**Australian Energy Regulator**

**Victorian Electricity Transmission Revenue Reset**

**AER Draft Determination**

**The Energy Users Coalition of Victoria**

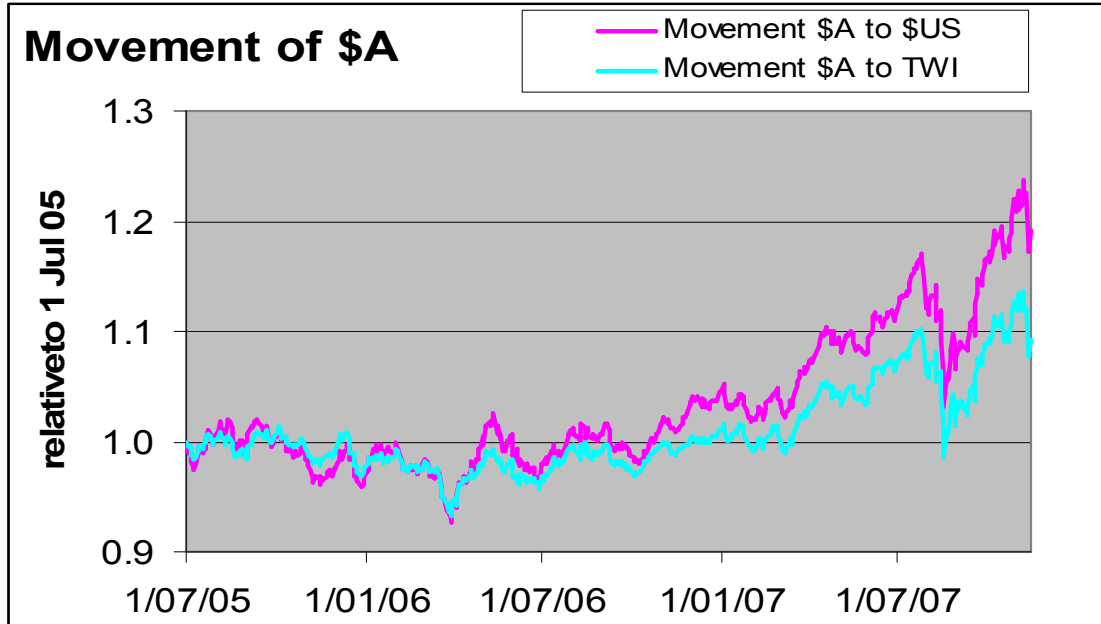
**In its submission to the AER on the SPA application, the EUCV pointed out that the rising \$A would have an impact on the cost of equipment needed (and even made the suggestion that SPA could use Chinese equipment like many Australian businesses have). The fact that the \$A has risen significantly must be an essential element of any assessment made of future costs for capital works. Unfortunately the AER has completely overlooked this element in assessing capital works costs.**

**The AER made a detailed assessment to develop the view that the capex for the next period should be inflated for expected increases in costs for materials and labour, yet it has completely overlooked that the \$A costs for capital equipment imported would have fallen. Therefore, as a basic calculation, the AER should have discounted the costs for imported equipment for year 2008 as a starting point.**

The EUCV sees that the AER has been remiss in not identifying this element of price movements

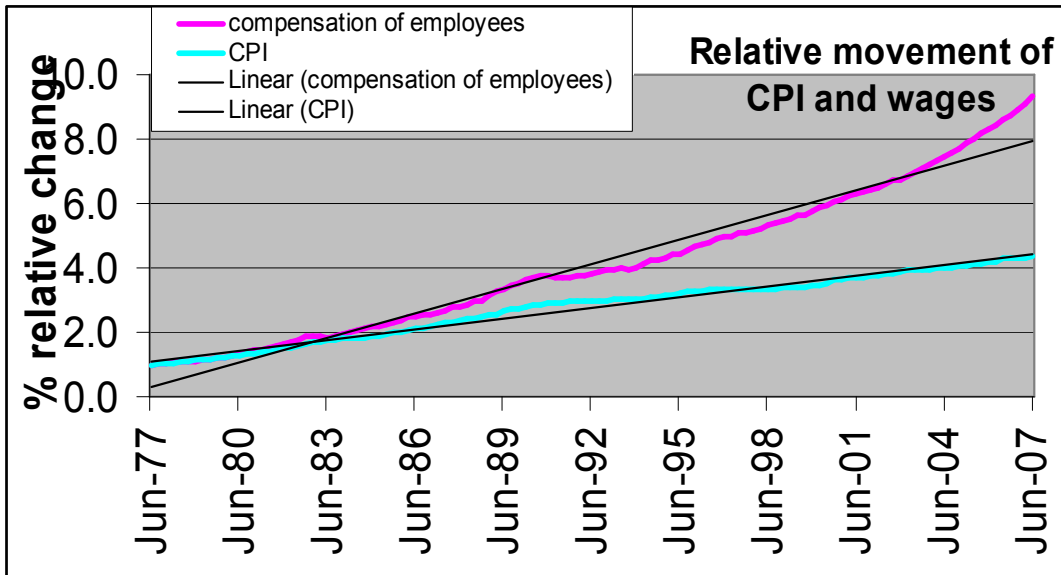
This shows that growth in employee compensation has consistently outperformed CPI over the past 30 years. In fact, the trend lines imply that CPI has grown at an average of about 5% per annum over this time, and wages have grown by an average 7.2% (or higher) over the same time.

**It also shows that wages have always outperformed CPI by at least 2.2% (and probably higher) and the view that this is an anomaly applying only to the near future is purely fallacious. This information was provided to the AER in the EUCV submission on the SPA application, yet the AER makes no reference to this underlying trend at all.**

**The EUCV considers that as there is an underlying trend for wages to consistently demonstrate a premium over CPI, then it must, as a matter of equity to consumers, allow only an adjustment for the premium between the underlying trend and the expectation for the next period. For the AER to allow the full differential between wages and CPI as a basis for a step change, will create a regulatory precedent and enshrine this erroneous approach into the future.**
